ALERT SERVICE BULLETIN

SUBJECT: MAIN ROTOR DRIVE - MGB emergency spraying system

Increase in the reliability of the EMLUB system by addition of a relay
 Corresponds to modification 0728369

Revision No.	Date of issue
Revision 0	2016-08-31
Revision 1	2016-10-07

Figure 1: Support, relay

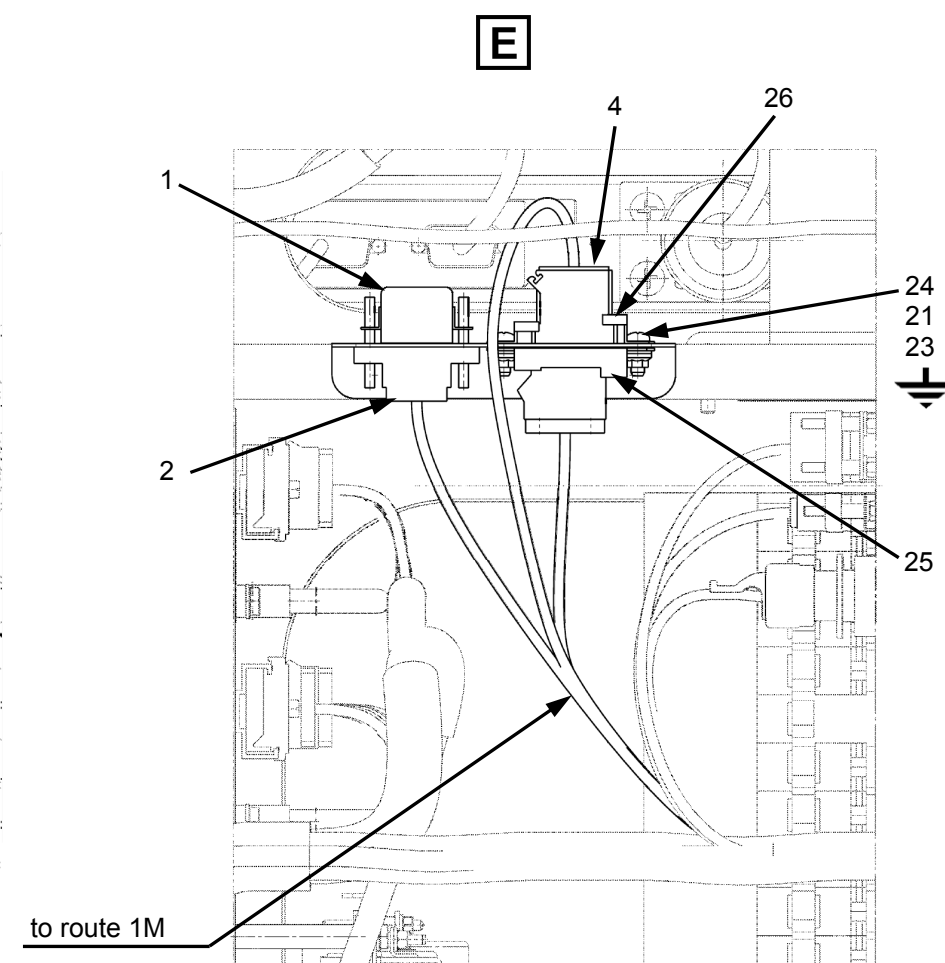
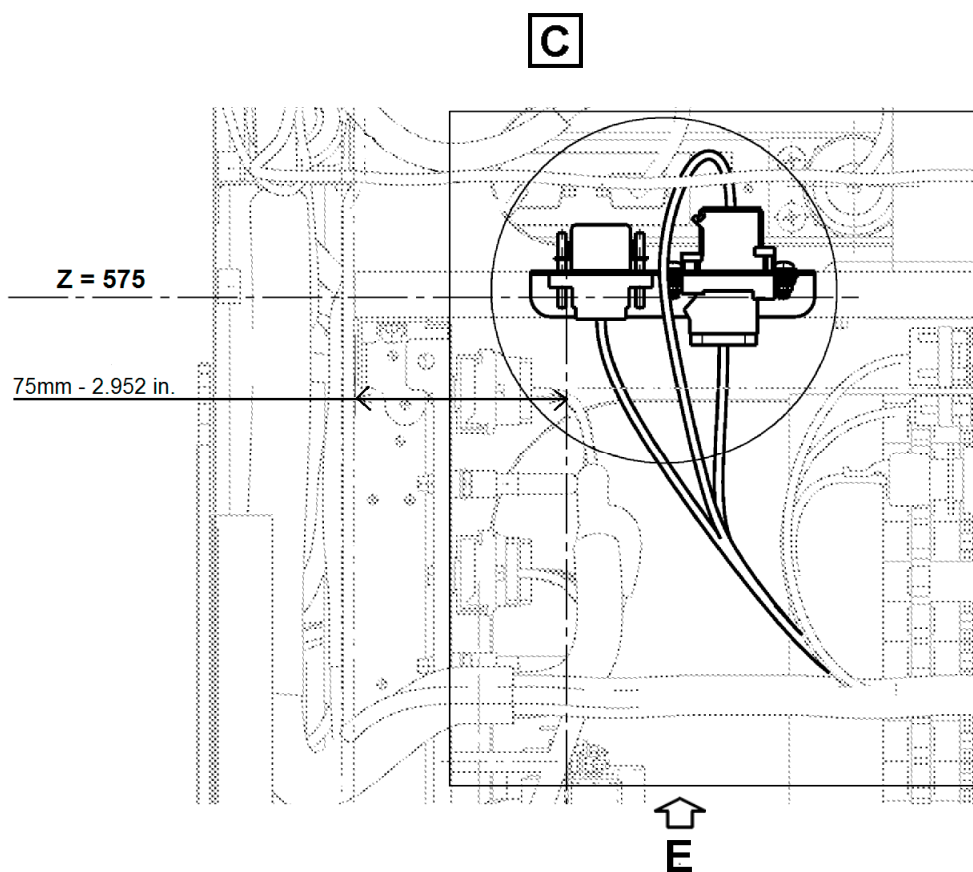
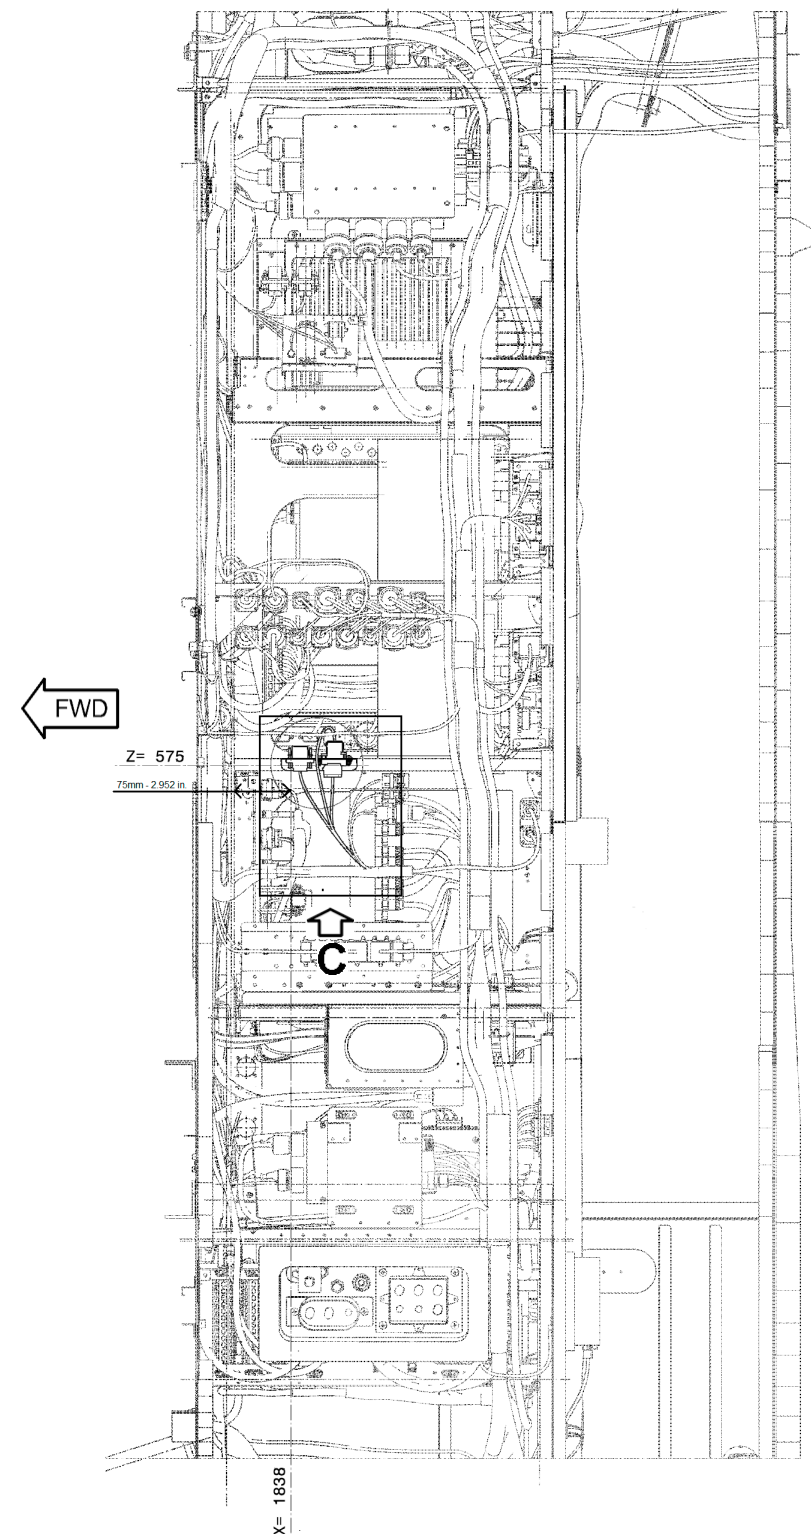
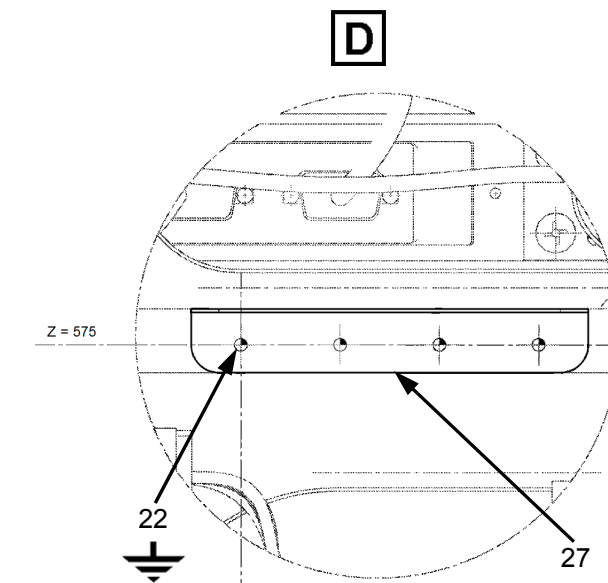
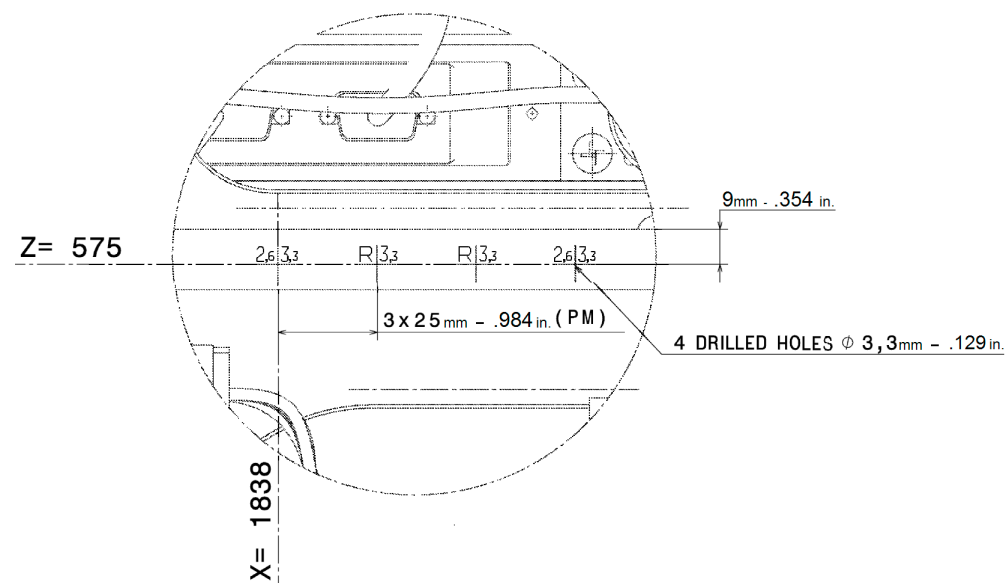
3.B.2.a. Installation of relay support (27) (Figure 1)

- Obey dimensions of Figure 1:
 - . Drill and deburr holes as per detail B.
 - . Do the electrical bonding as per Detail D and as per MTC Work Card 20.02.07.401.
 - . using rivets (22), install relay support (27).
- Install module individual supports (25) and (26).
- Install relay base (2).
- Do the electrical bonding as per detail E and as per MTC Work Card 20.02.07.407.
- Using screws (24), washers (21) and nuts (23), install diode module (4).

- . Test electrical continuity of installed wiring.
 - . Install relay (1) identified "14QK" (Detail E, Figure 1).
- Bond marks "14QK", "897VT1" and "897VT2" from set of markers (7).

Figure 2: PRE MOD 0728369

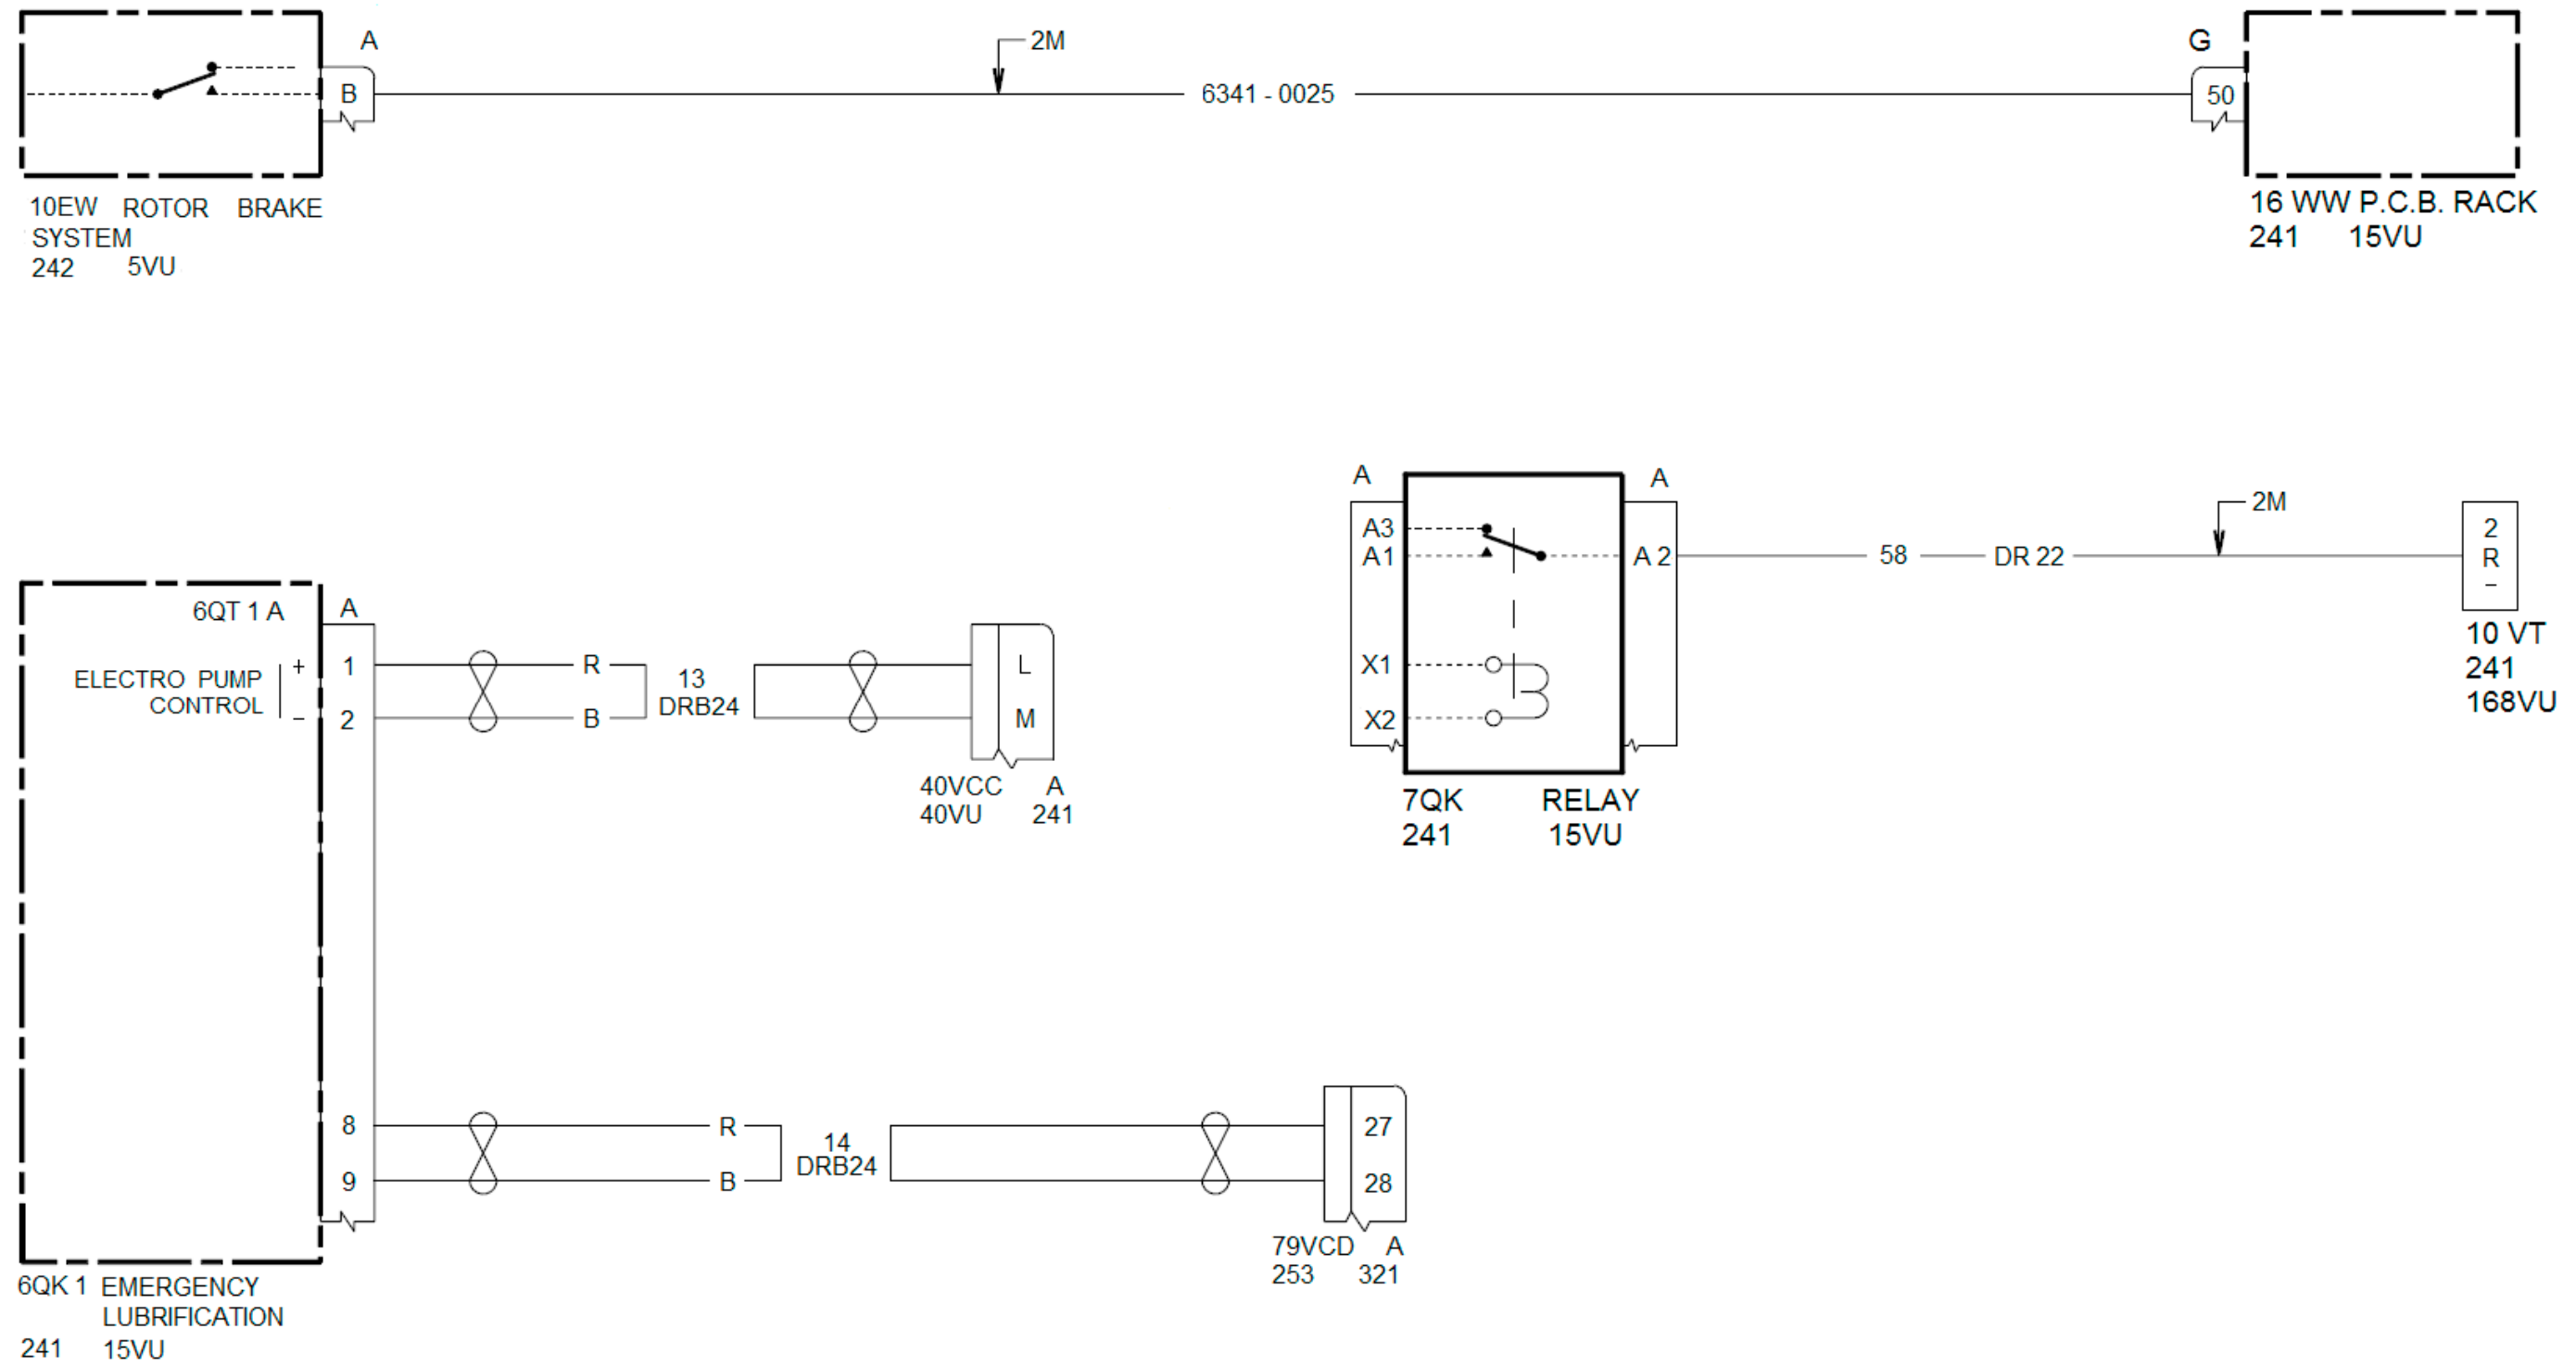
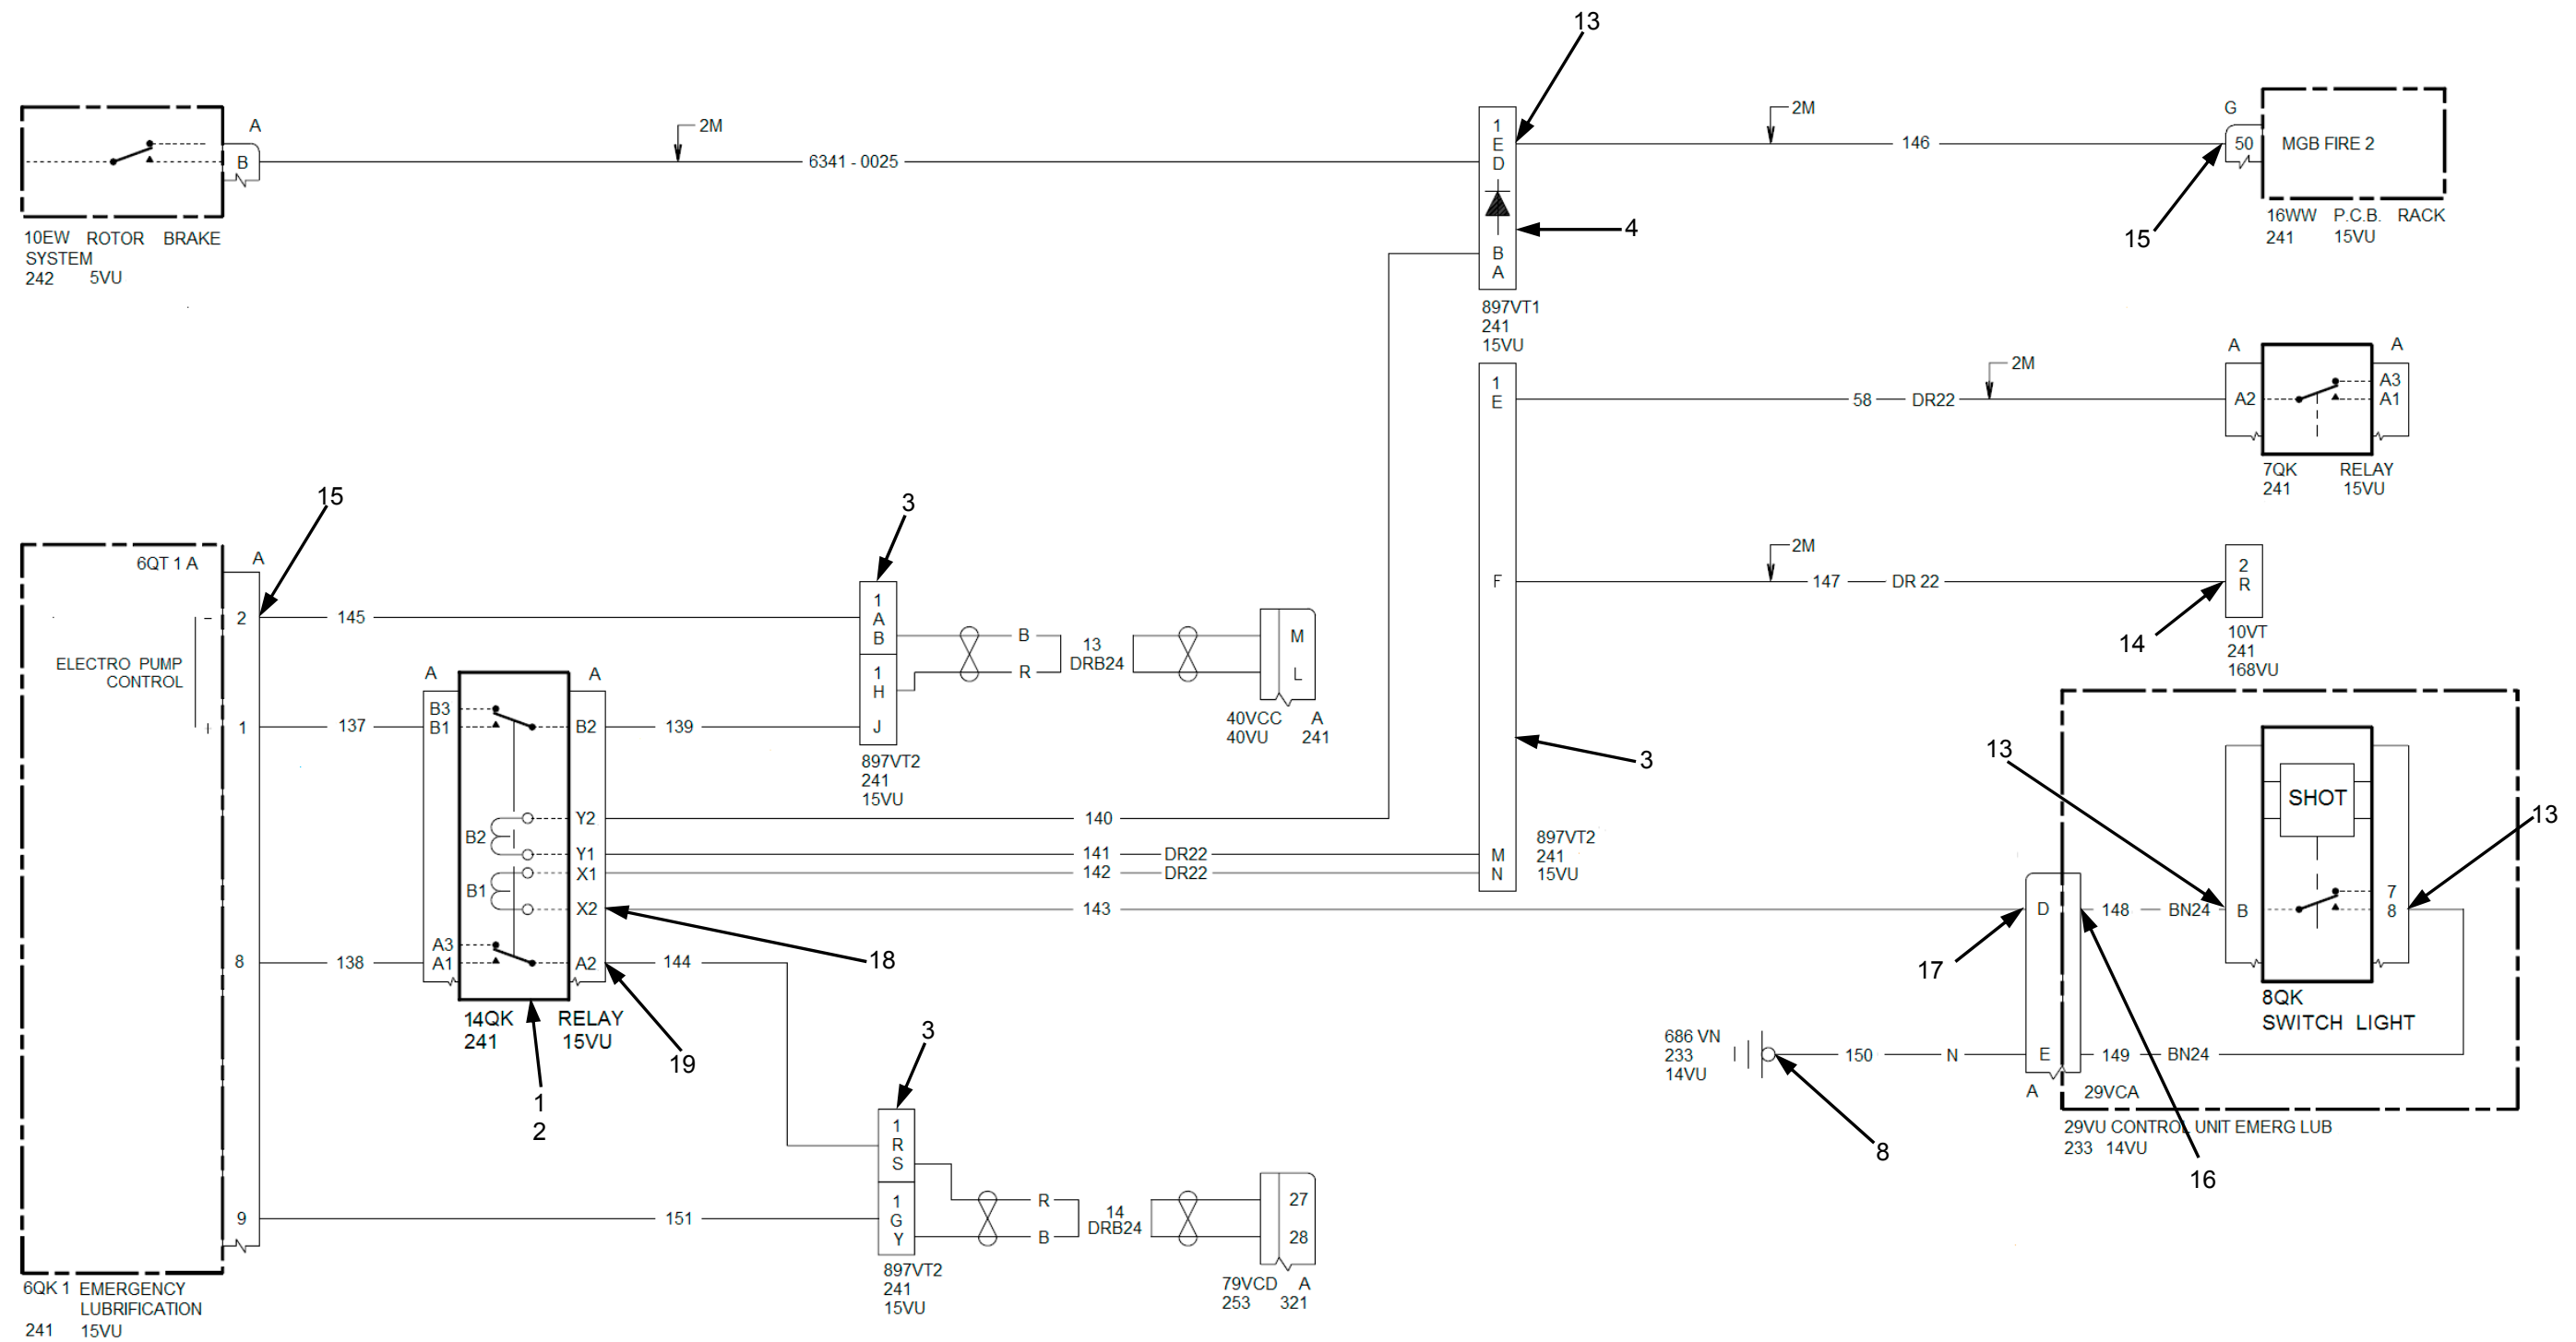
This ALERT SERVICE BULLETIN requires the addition of an electrical relay whose function is to confirm the presence of the EMLUB electronic control card signal which is generated by the crew by manually pressing the "SHOT" button, thus activating the EMLUB system.

This ALERT SERVICE BULLETIN consists in adding a relay to the EMLUB system in order to increase its reliability.

Figure 3: POST MOD 0728369
